From: Donald Sterk <donsterk@gmail.com>
Sent: Monday, January 14, 2019 11:02 PM
To: Marshall Johnson
Cc: Don Sterk; Steve Le
Subject: Re: El Camino Specific Plan

EL CAMINO REAL SPECIFIC PLAN

Workshop #3

EL CAMINO REAL SPECIFIC PLAN COMMENTS

EL CAMINO REAL SOUTH SIDE
SHOWING THE GROWTH HEIGHT AND SCREENING
OF A PALM TREE

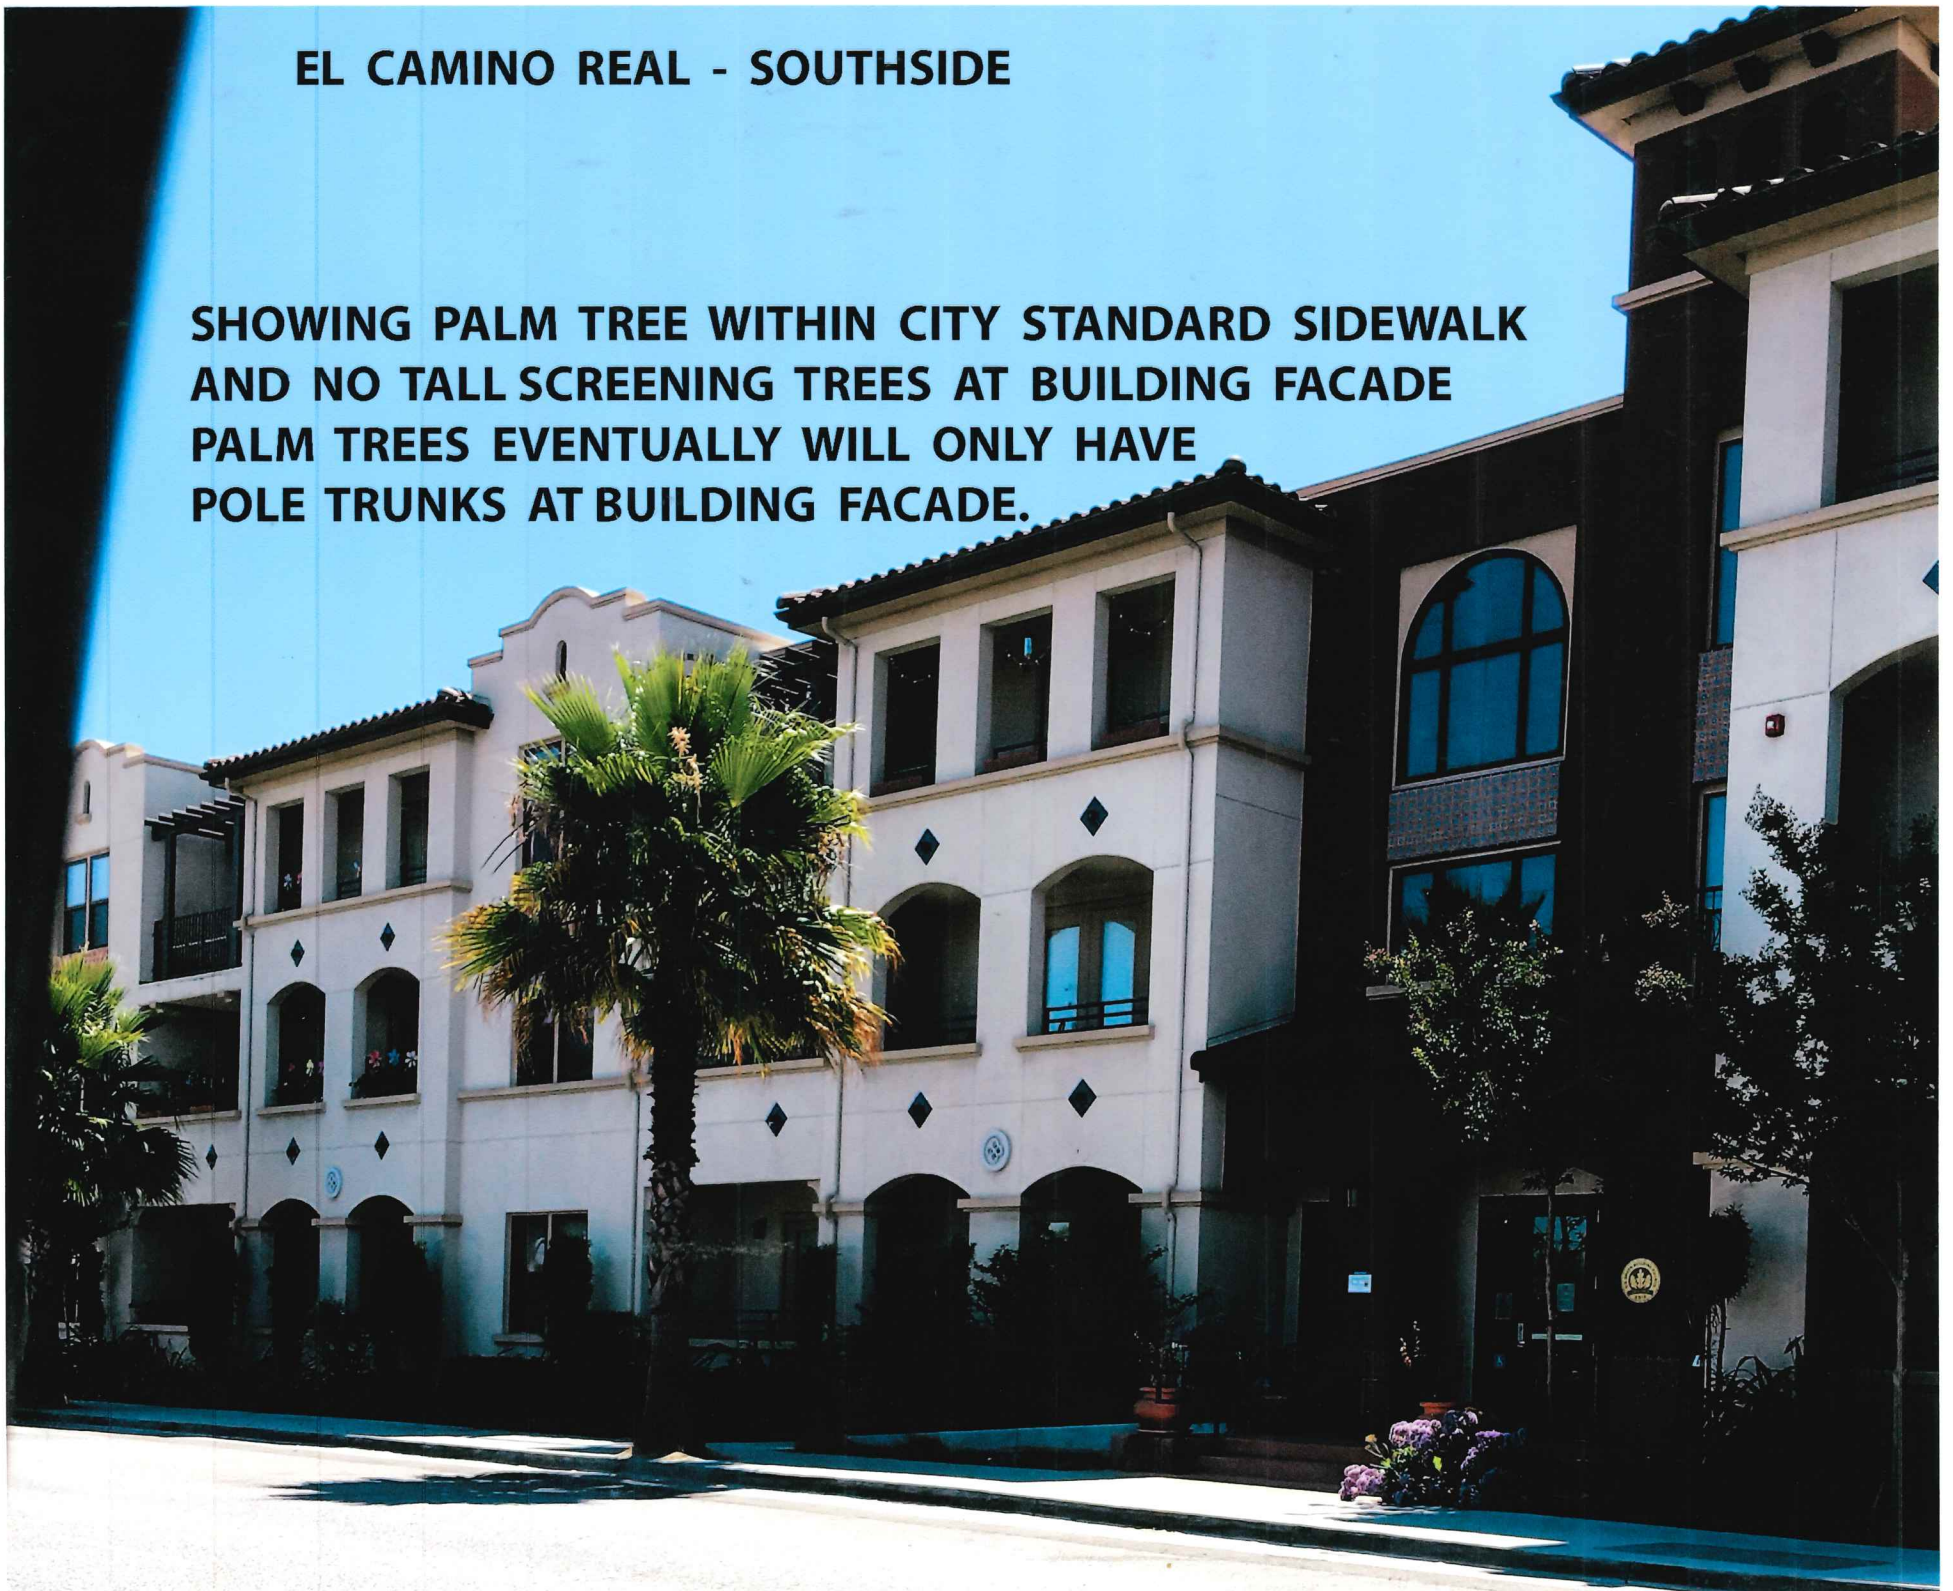
**EL CAMINO REAL SOUTH SIDE.
SHOWING CONFLICT BETWEEN
GROWING PALM TREE AND
OVERHANGING BALCONY.**

**EL CAMINO REAL NORTH SIDE.
SHOWING ILLUMINATION LEVEL WITH BUILDING
DOWN LIGHTS AND CITY DETORATIVE DUAL
LIGHTING FIXTURE. 14. ftcds
NO GROUND COVER LANDSCAPING.**

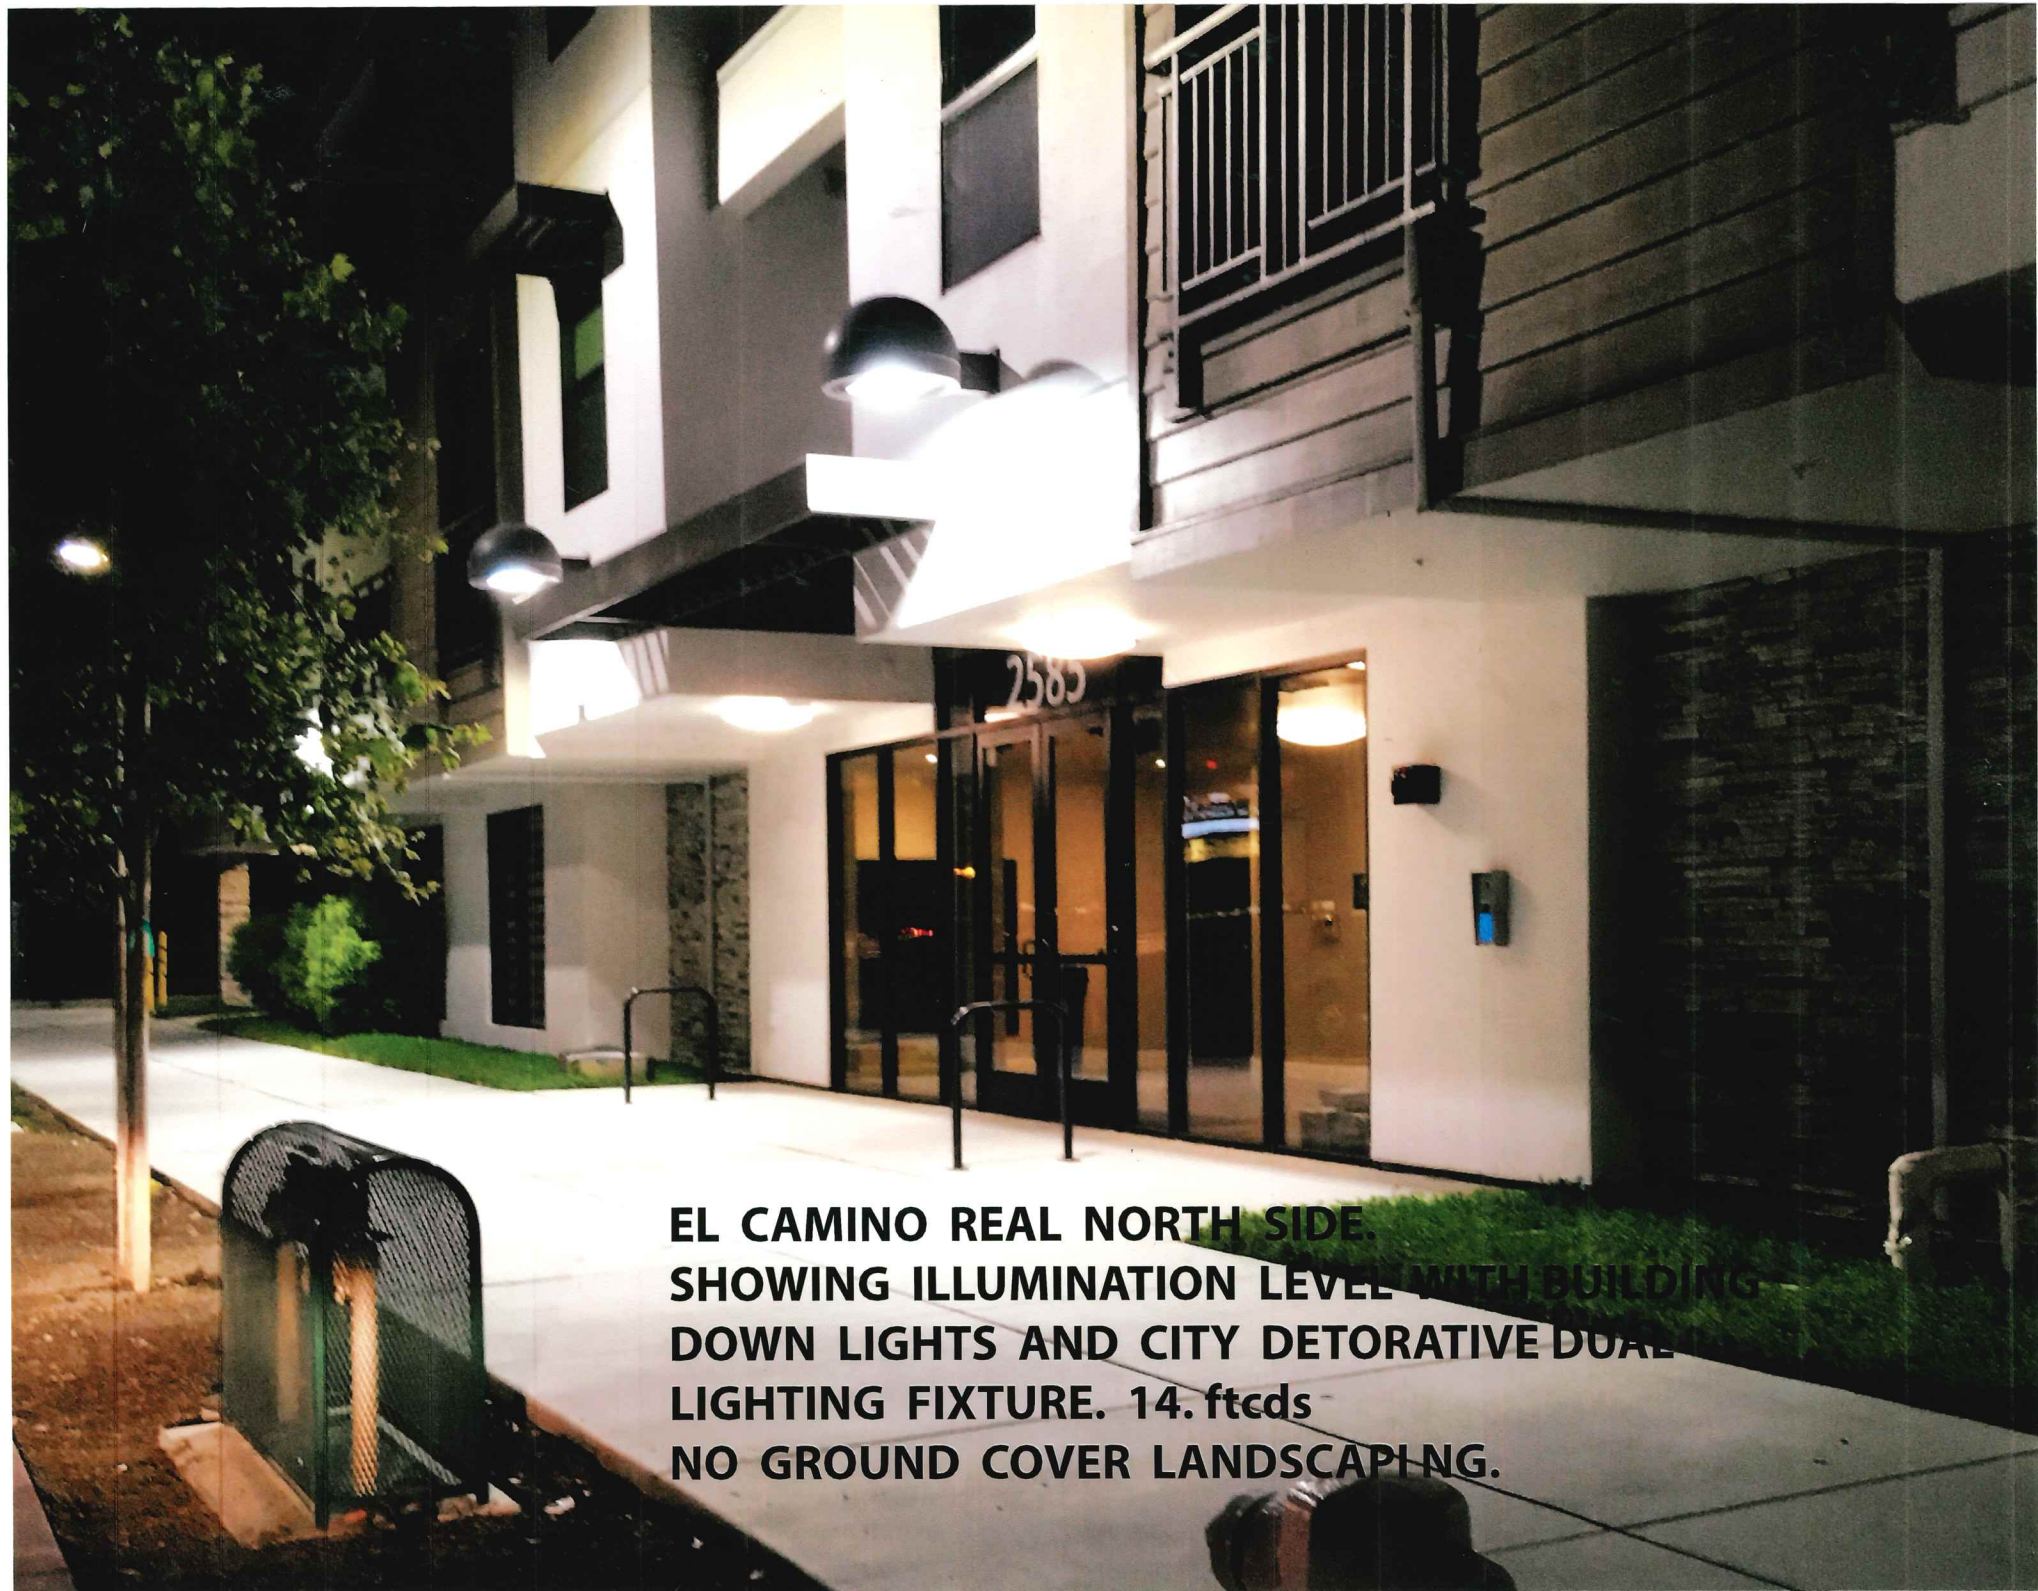
**ALSO, BOLLARD DOWNLIGHT
AT PLANTER.**

**NORTHBOUND EL CAMINO REAL AT "AUTO ZONE"
SHOWING TREES FULLY OBSCURING STORE FRONT**

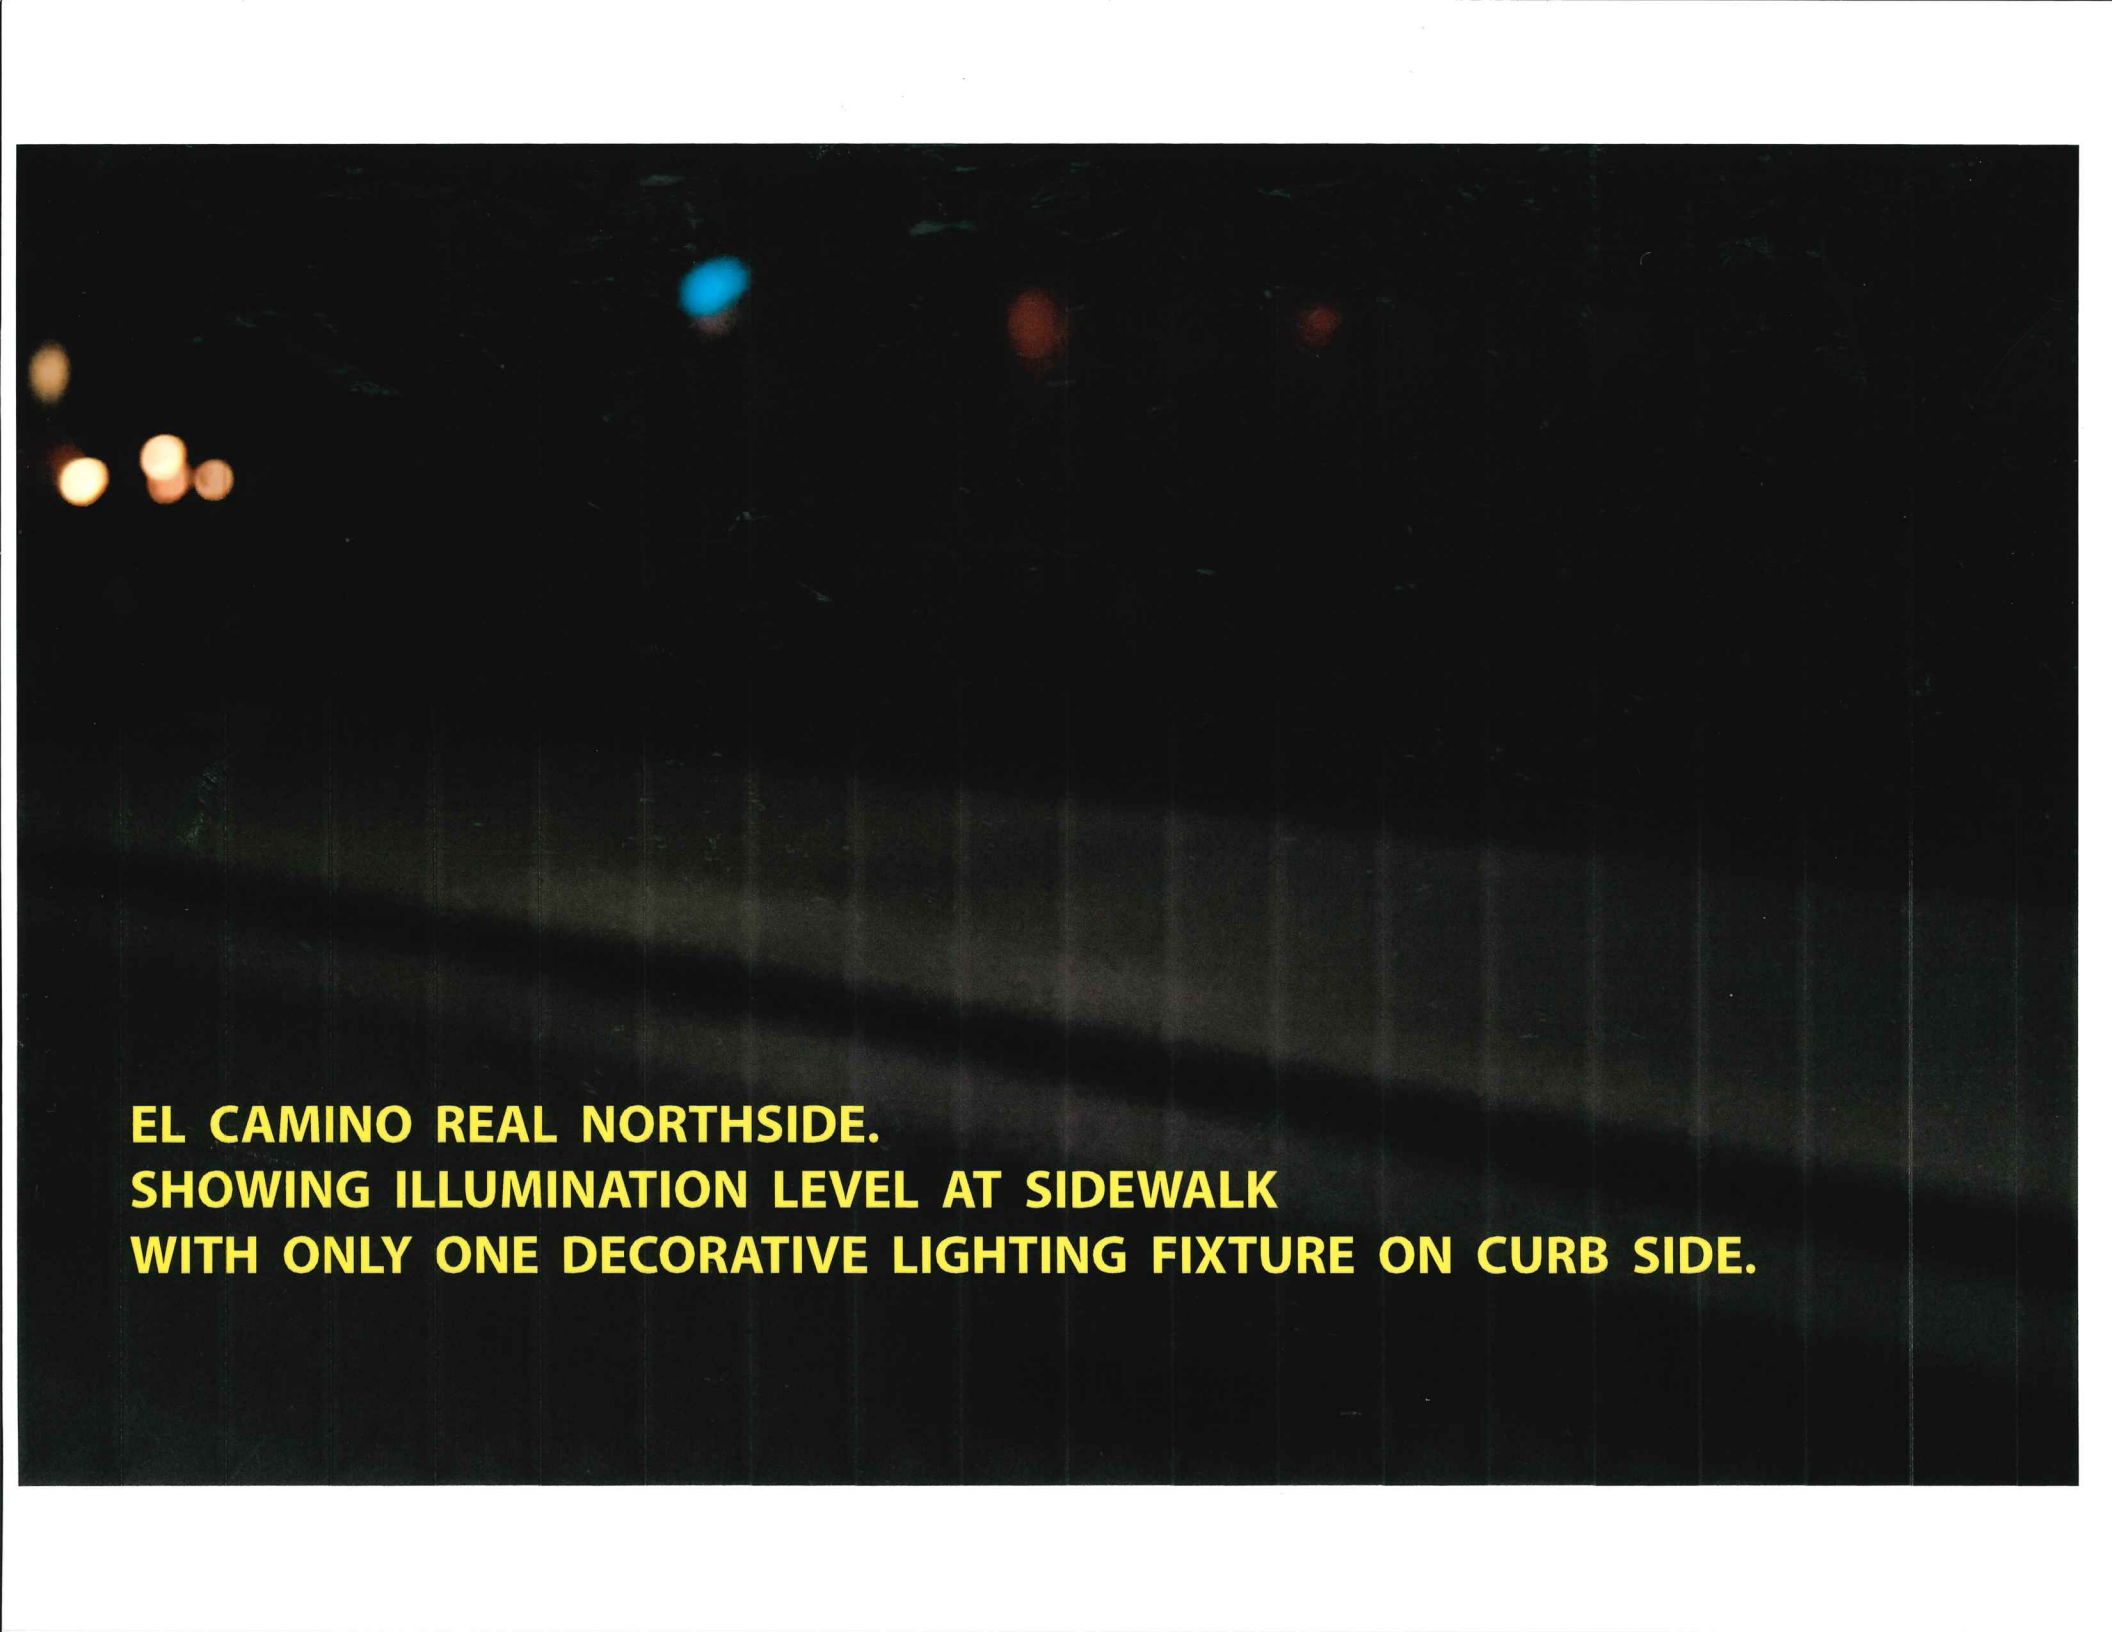
**EL CAMINO REAL NORTHSIDE.
SHOWING ILLUMINATION LEVEL AT SIDEWALK
WITH ONLY ONE DECORATIVE LIGHTING FIXTURE ON CURB SIDE.**
